UNITED STATES PATENT AND TRADEMARK OFFICE

APPLICATION NO.	FILING DATE	FIRST NAMED INVENTOR	ATTORNEY DOCKET NO.	CONFIRMATION NO.
10/685,954	10/15/2003	Todd M. Wenger	H1799-00180	7947
8933	7590	05/12/2006	EXAMINER	
DUANE MORRIS, LLP IP DEPARTMENT 30 SOUTH 17TH STREET PHILADELPHIA, PA 19103-4196			FORD, JOHN K	
			ART UNIT	PAPER NUMBER
			3753

Office Action Summary

Sheet 9 of 21

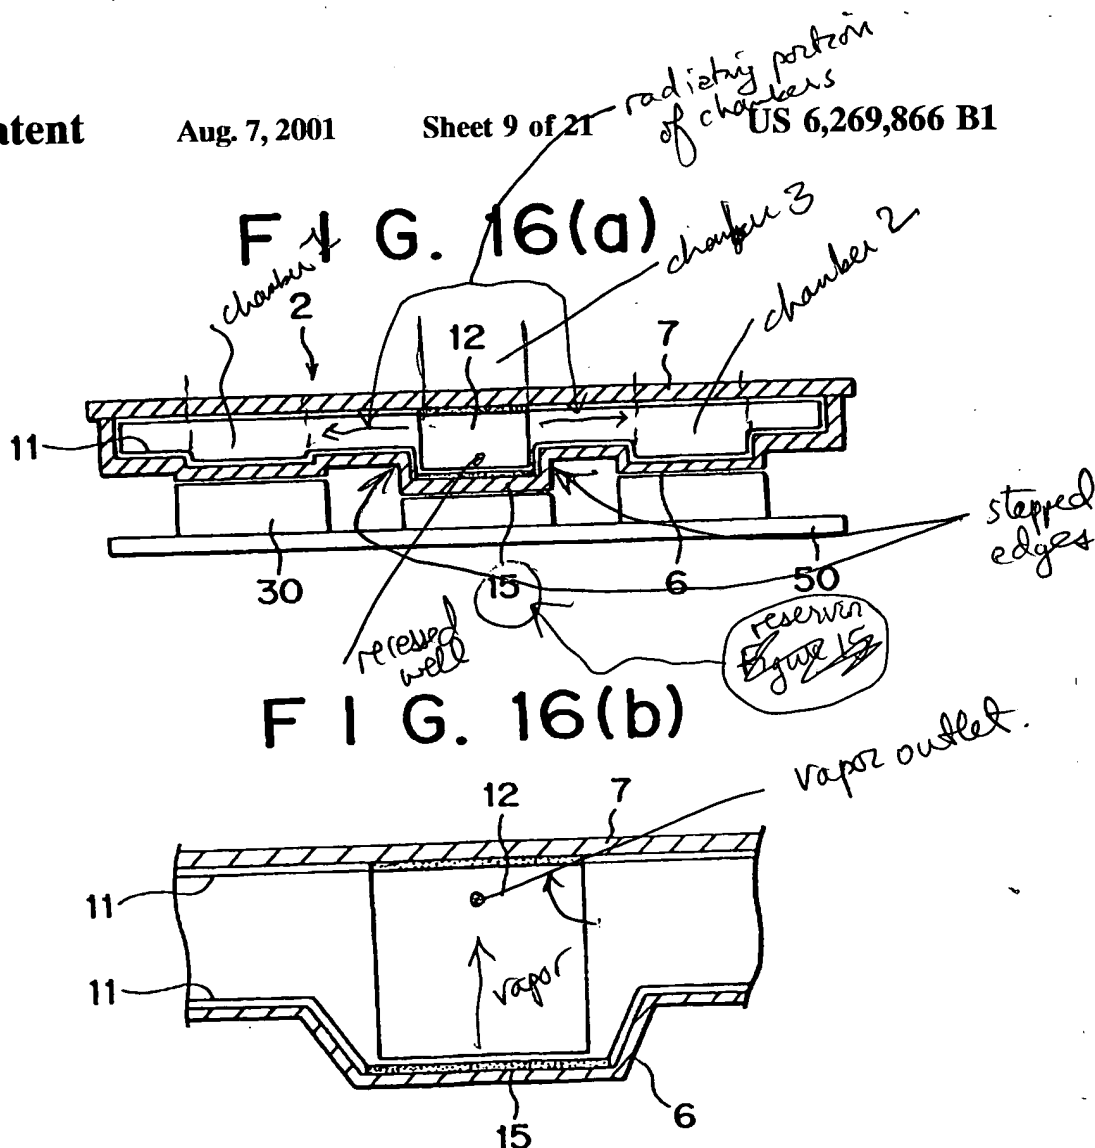
In particular regards to Figure 16, the central protrusion portion labeled 15 constitutes applicant's claimed "reservoir for the liquid phase." The wall area 6 above the two heat producing elements 30 on either side of the central protrusion portion 15 constitute applicant's "at least two spaced evaporation points." Regarding claim 4, see wicking material 11

Regarding claim 9, since a chamber, by definition, is simply an open space, for purposes of rejection the vertically projected area above each of the right-most, middle

and left-most heat producers 30 is deemed to be a chamber that radiates from the recessed well 15. Regarding claim 10, the chambers discussed immediately above being of different vertical depths are asymmetrically arranged relative to one another. Regarding claims 11-12, in col. 18, lines 55-60, Yamamoto discloses 100 Watt and 5 Watt heat loads. The 100 Watt heat load is located under the central recess portion. For claim 13, see Figure 27b, and for purposes of rejection, one chamber is defined over both 15e and 15d, absent any precise limitation in the claims as to what constitutes a chamber. See diagram below.
